Sacramento Convention Center Renovation and Expansion and 15th/K Street Hotel Projects

Final Environmental Impact Report | June 2018

TABLE OF CONTENTS

Figure 2-4
Project Concept Design/Building Massing

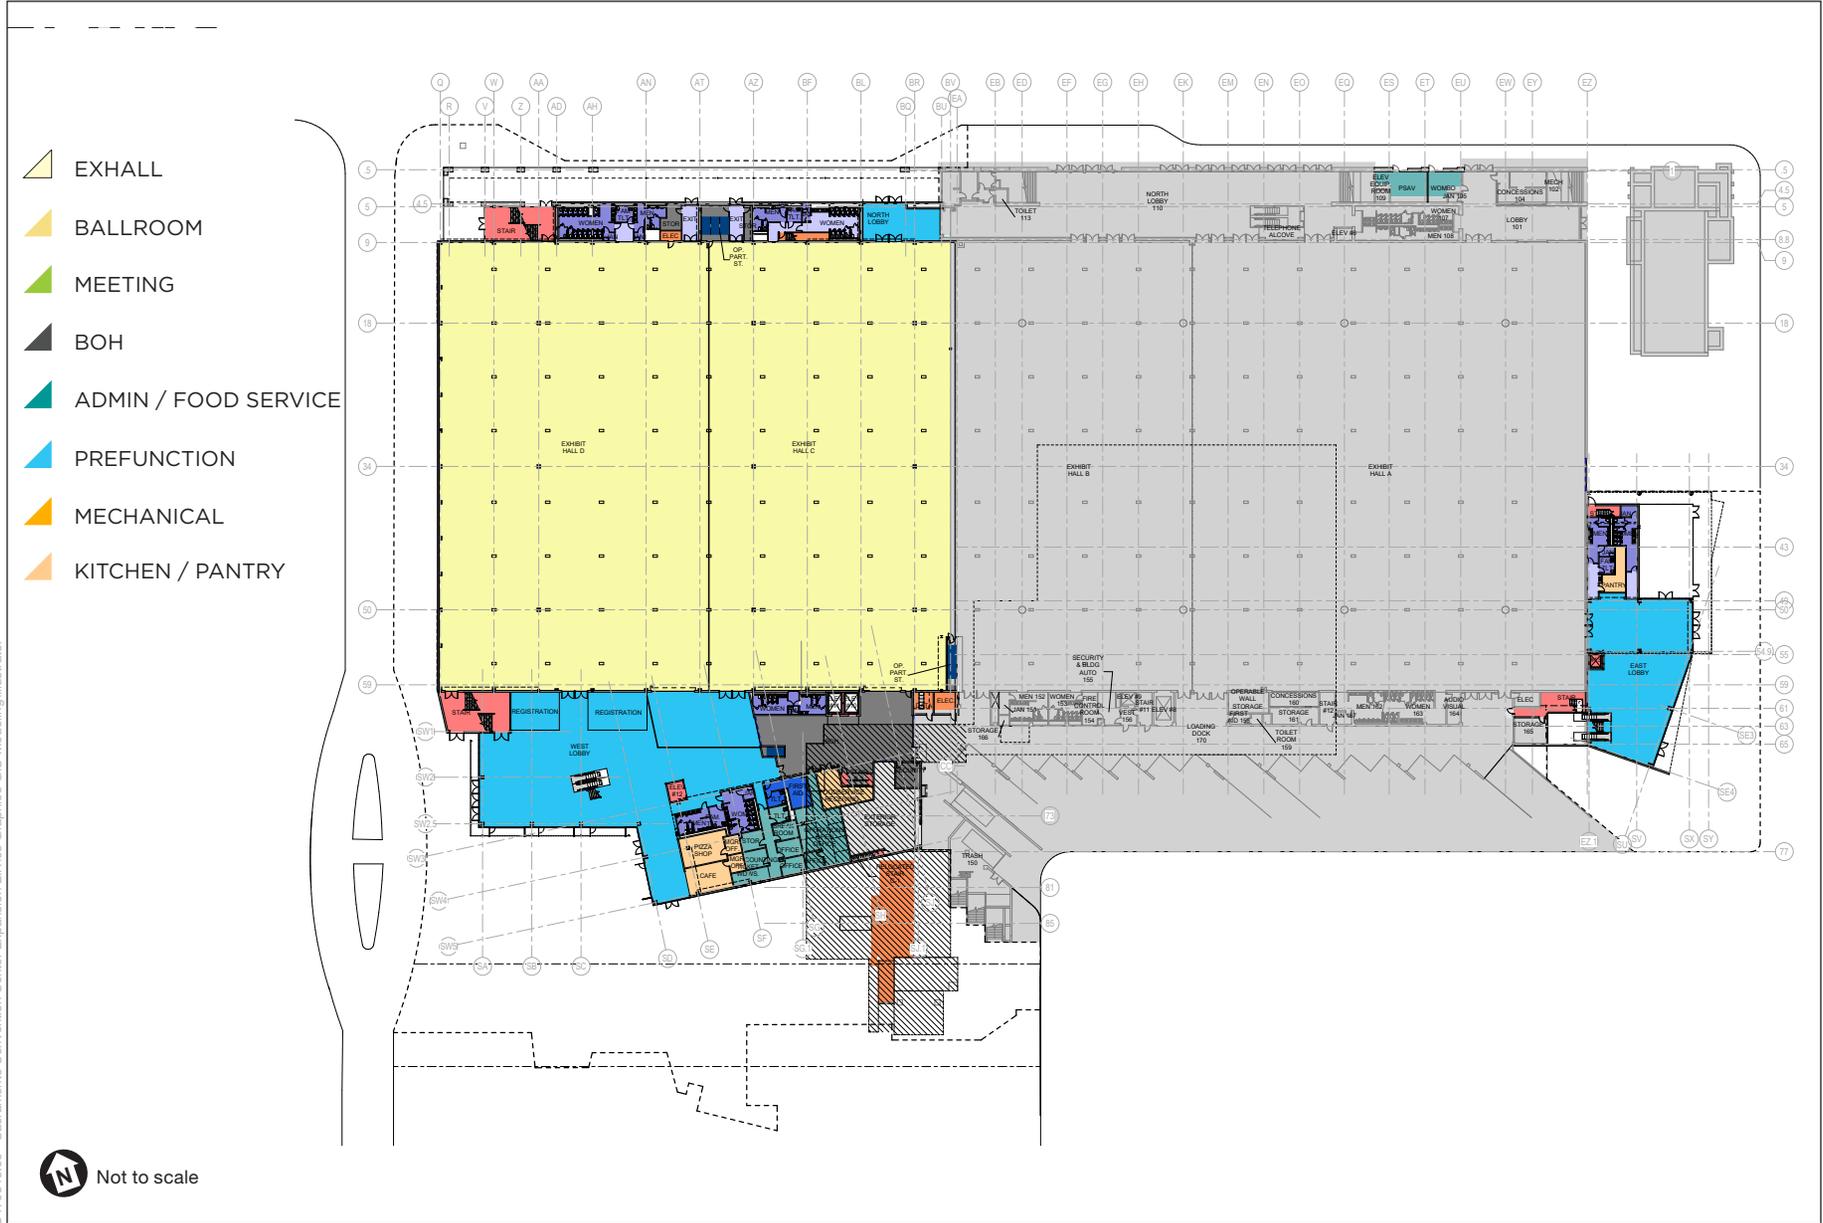
Figure 2-4, Project Concept Design/Building Massing, is revised to show updated SCC project design.

Figure 2-7
Project Landscape Concept Terrace Plan

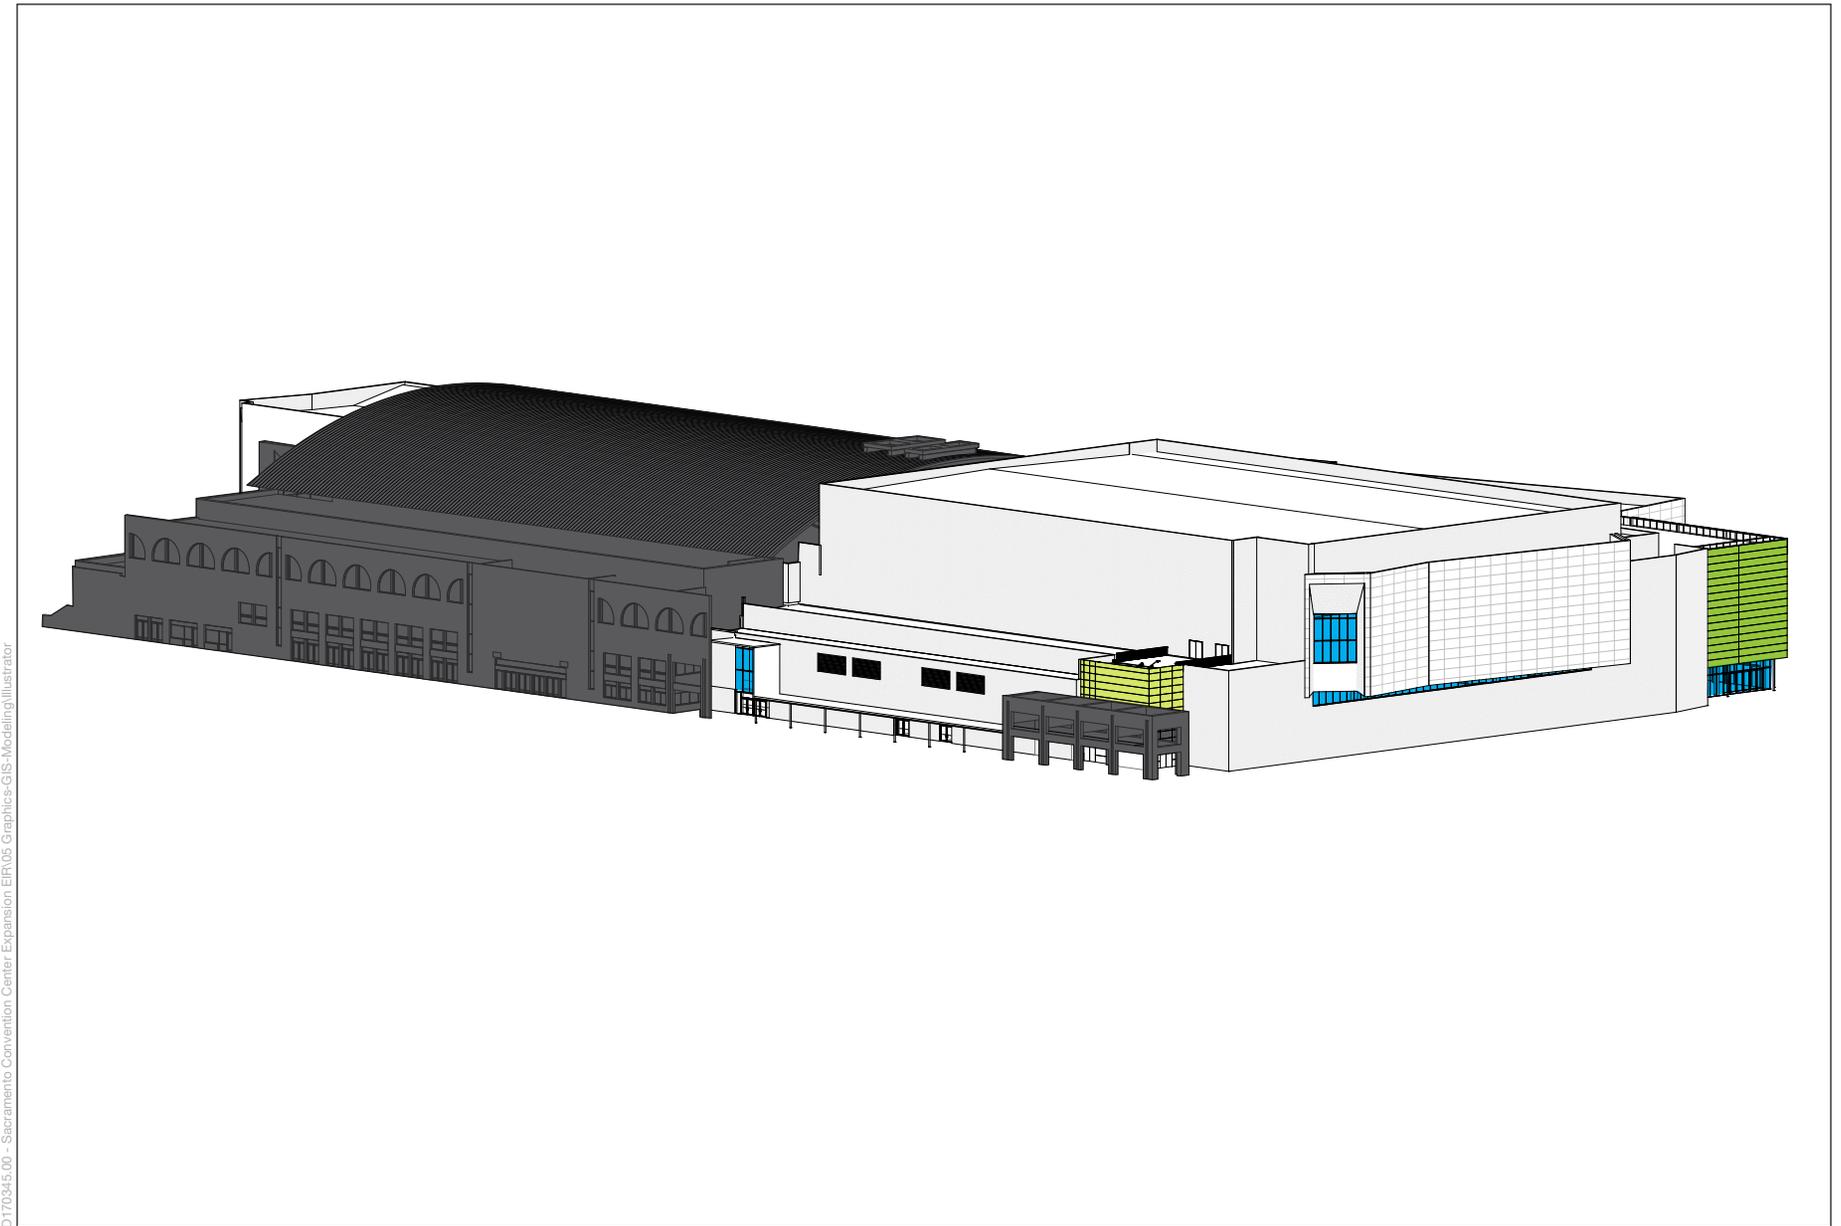
Figure 2-7, Project Landscape Concept Terrace Plan, is revised to show the revised plan for the Activities Plaza.

Figure 2-8
North View of Renovated and Expanded SCC Structure

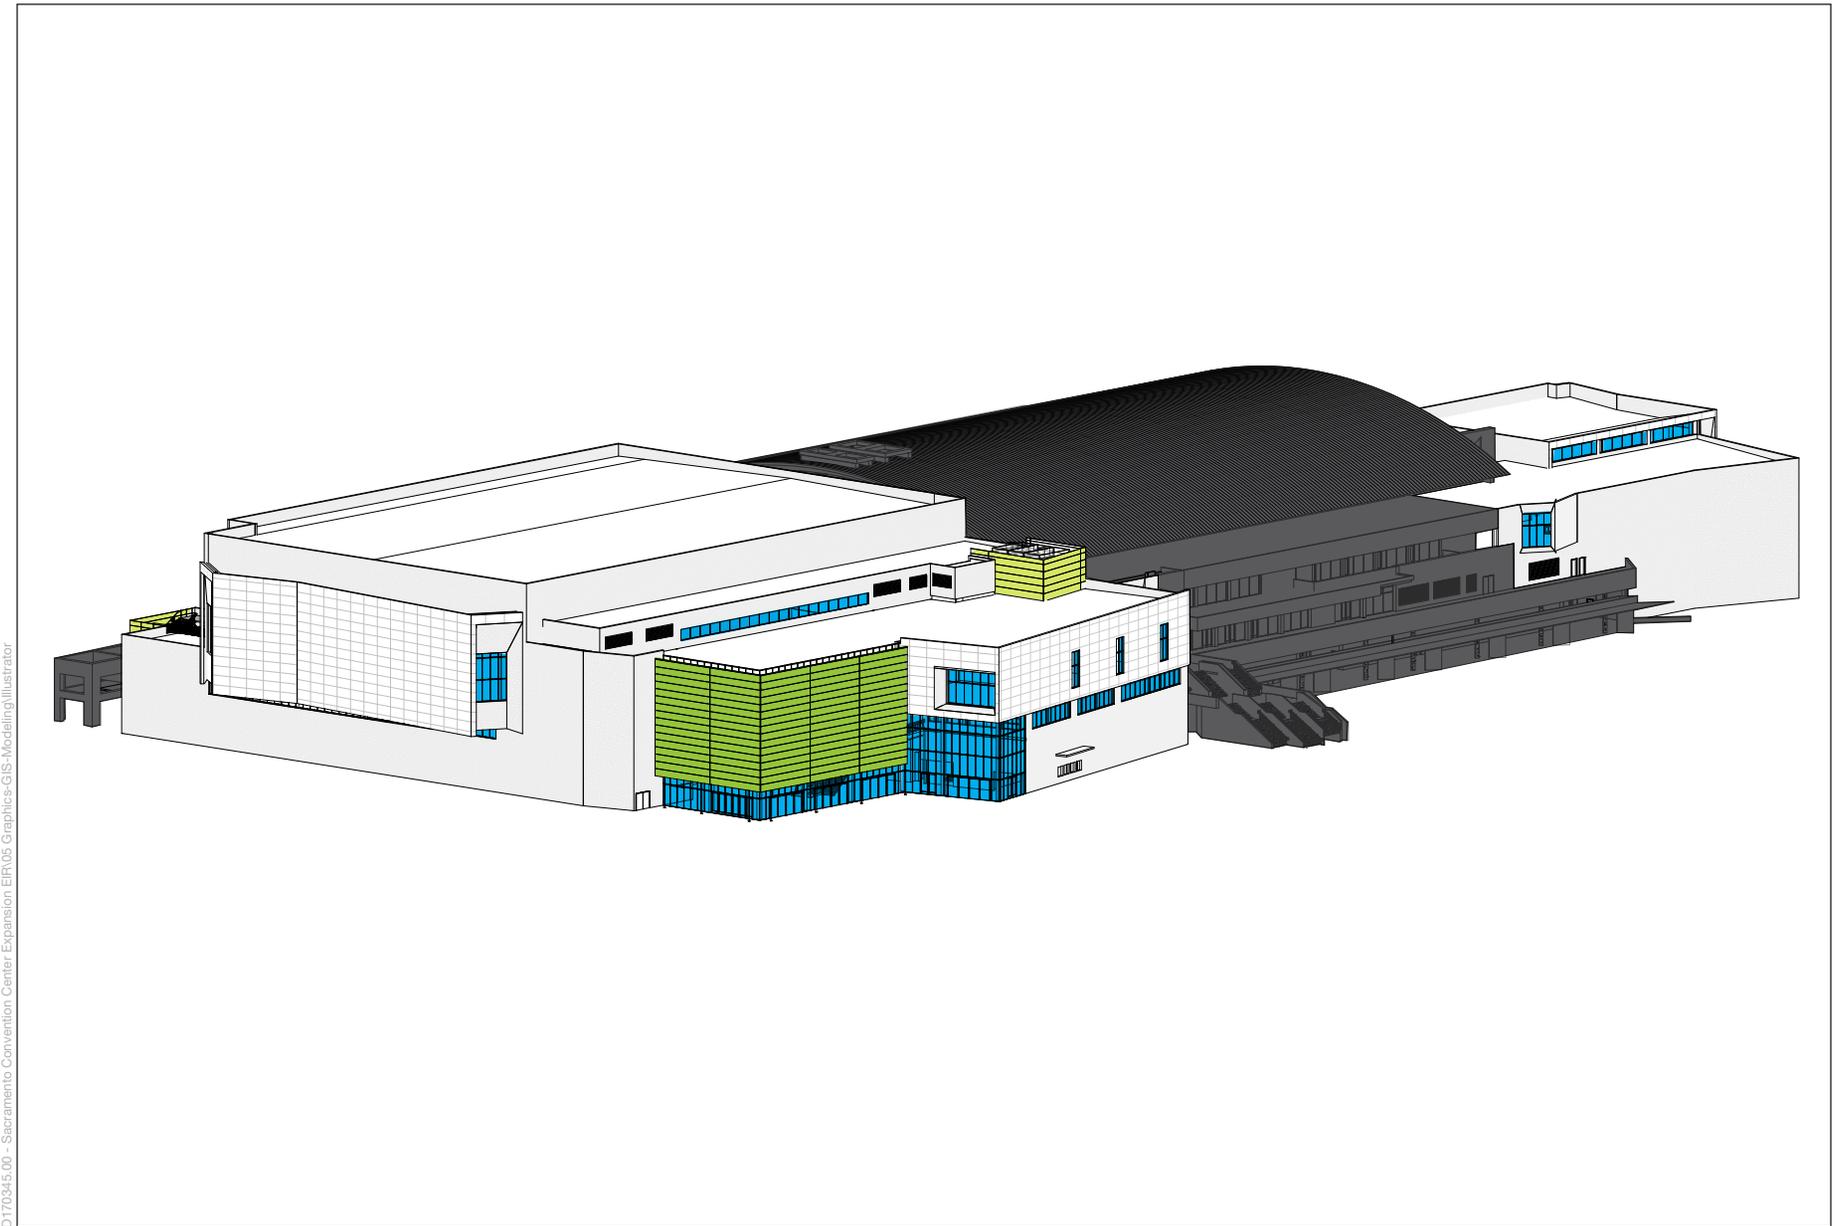
Figure 2-8, SCC J Street Elevation, is revised to show the revised north view of the SCC and is retitled to “North View of Renovated and Expanded SCC Structure.”

Figure 2-9
West View of Renovated and Expanded SCC Structure

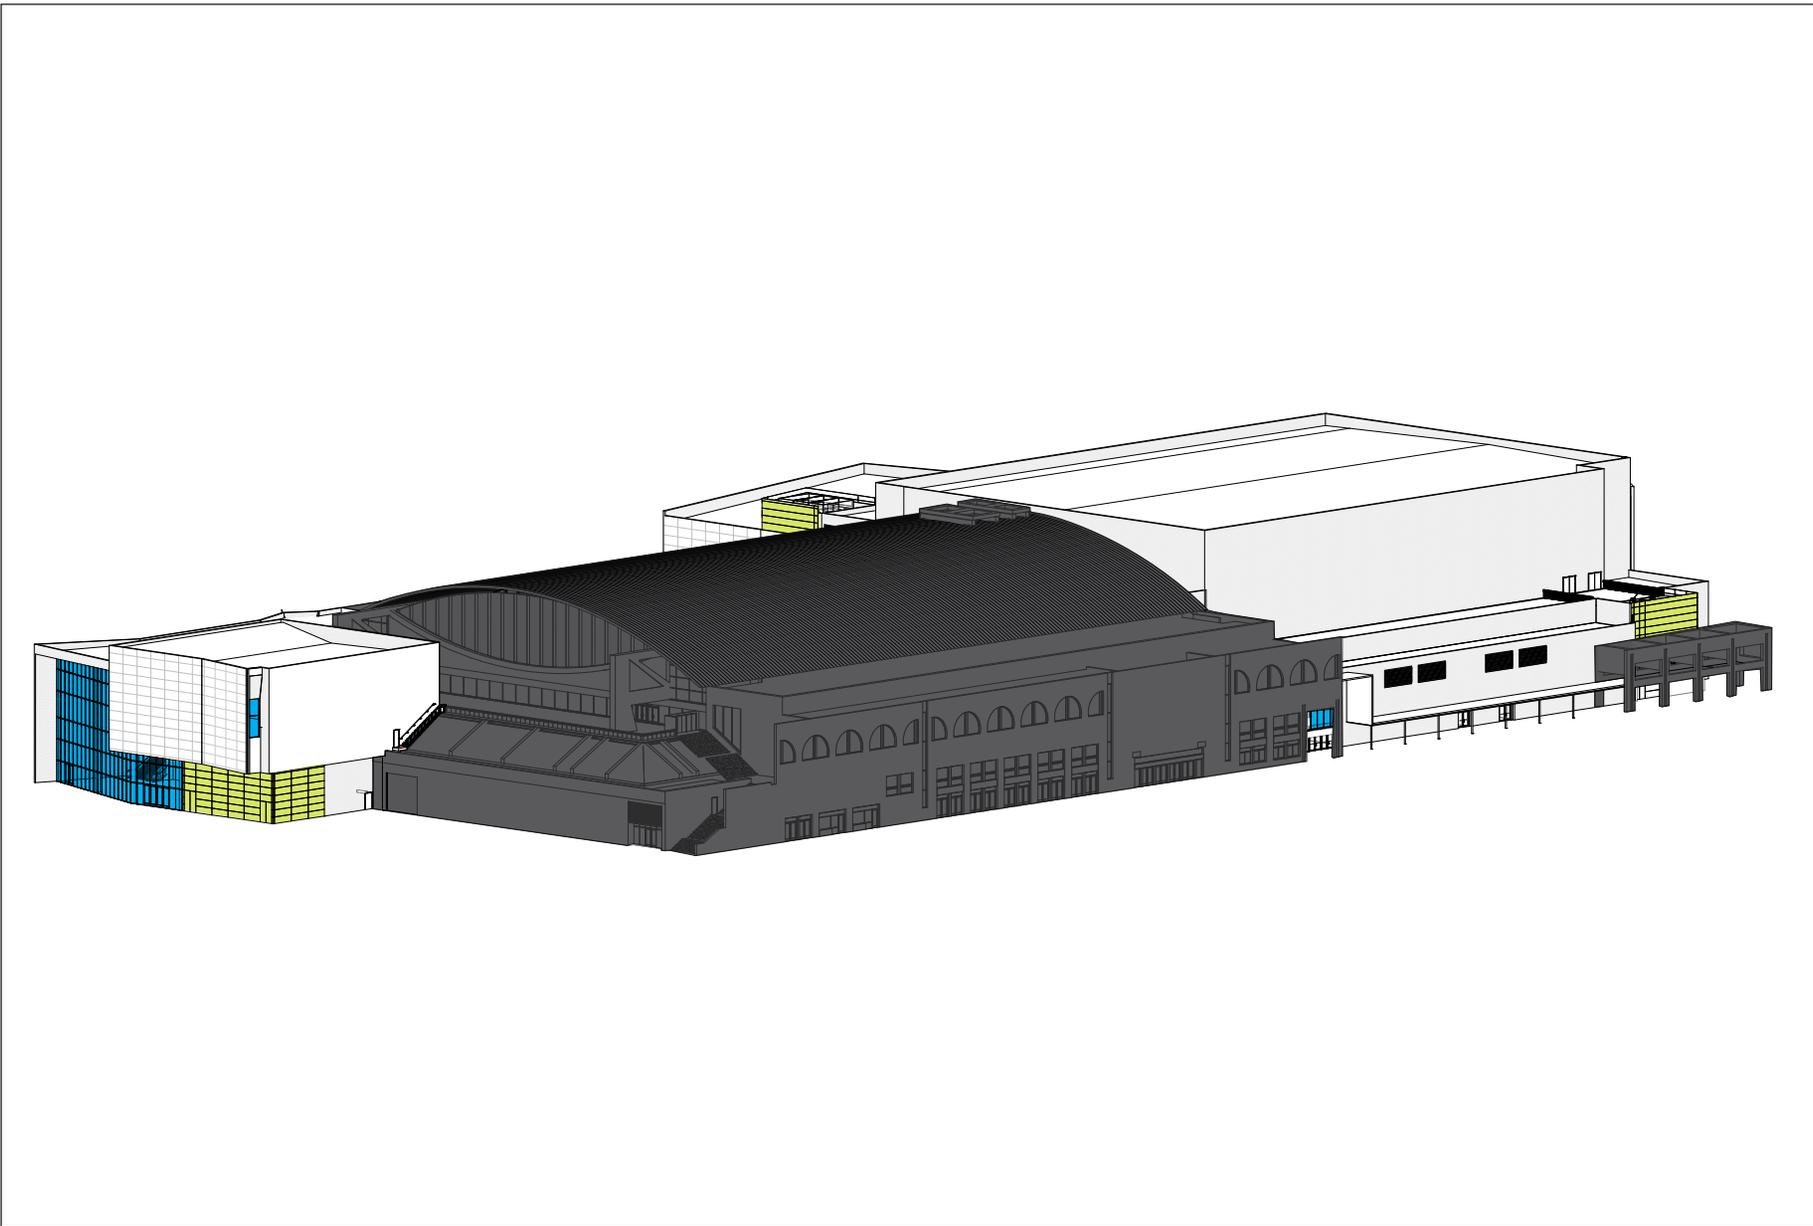
Figure 2-9, SCC 13th Street Elevation, is revised to show the revised west view of the SCC and is retitled to “West View of Renovated and Expanded SCC Structure.”

Figure 2-10
East View of Renovated and Expanded SCC Structure

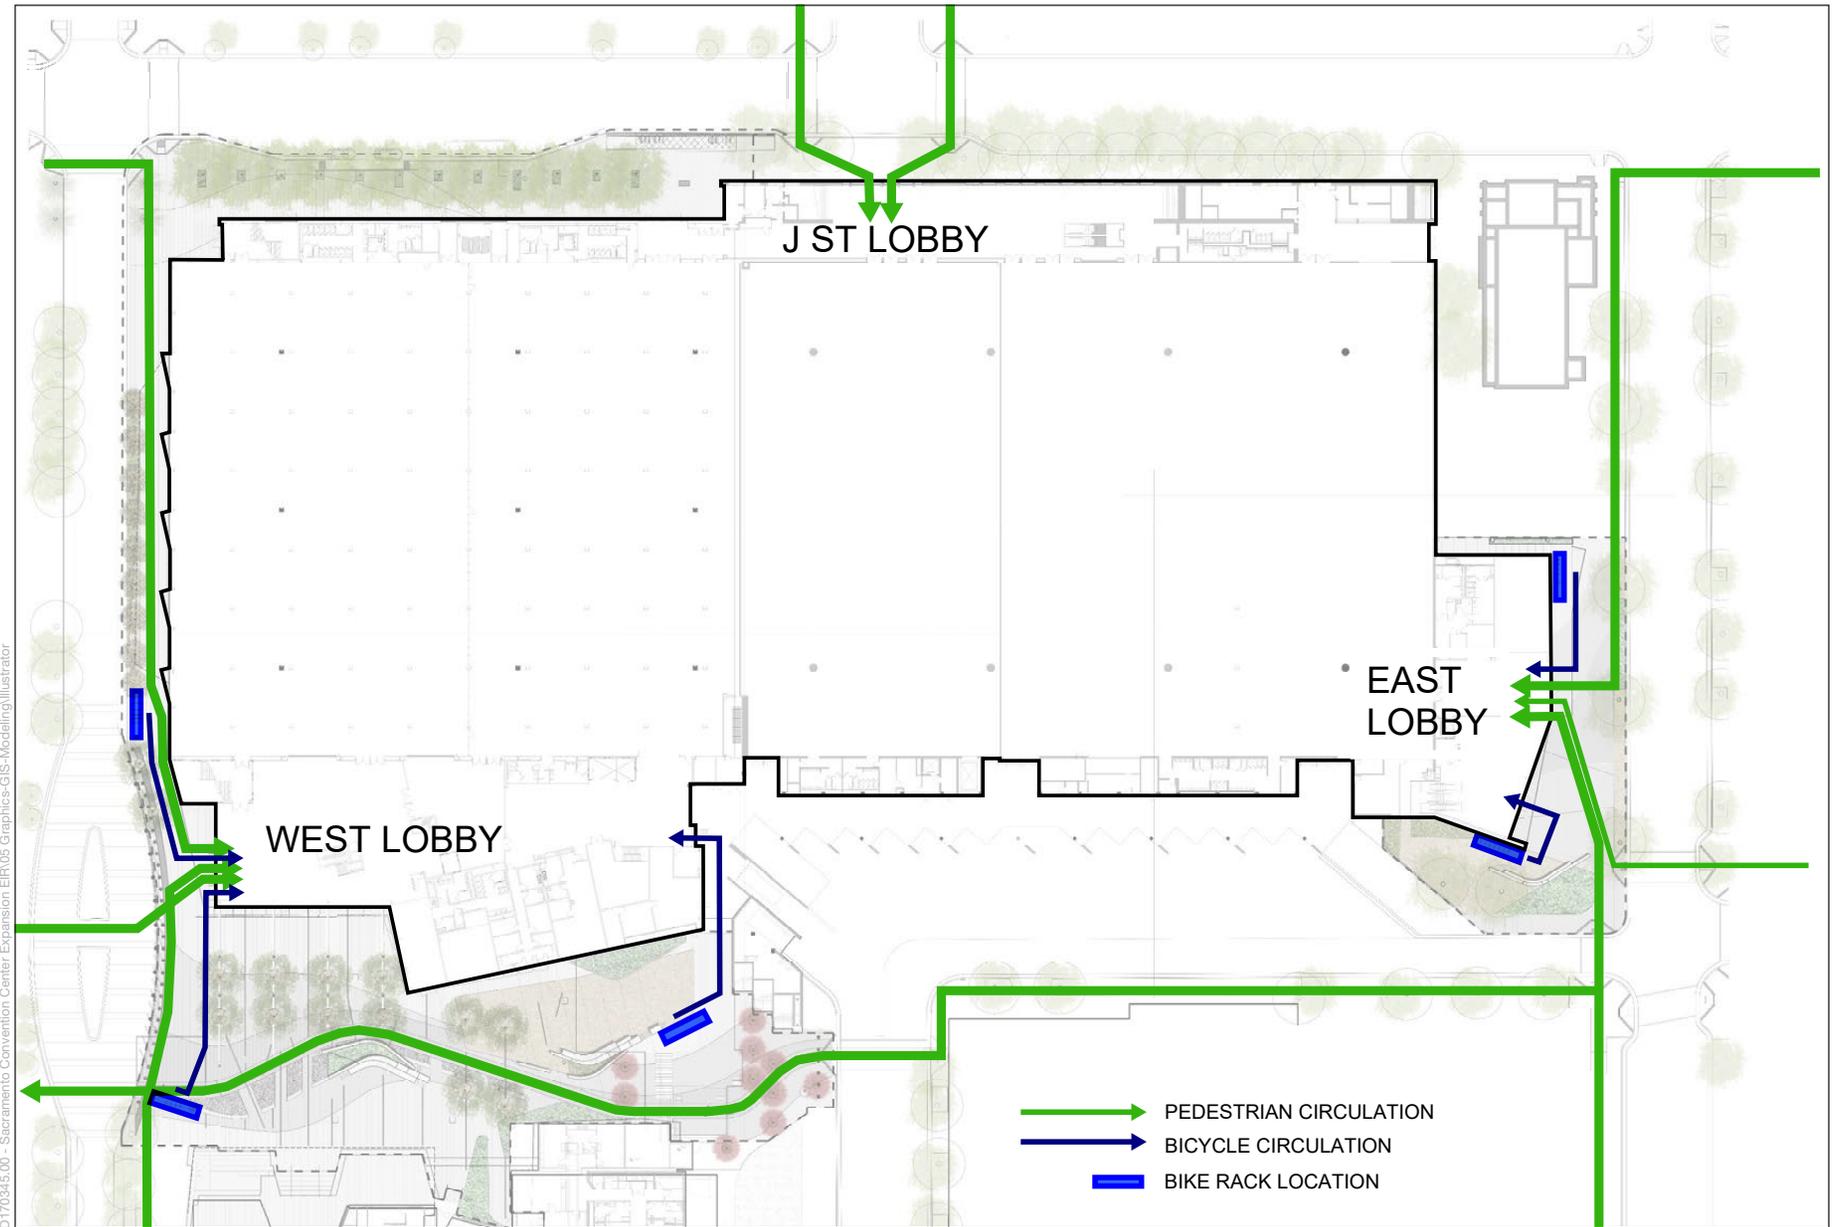
Figure 2-10, SCC 15th Street Elevation, is revised to show the revised east view of the SCC and is retitled to “East View of Renovated and Expanded SCC Structure.”
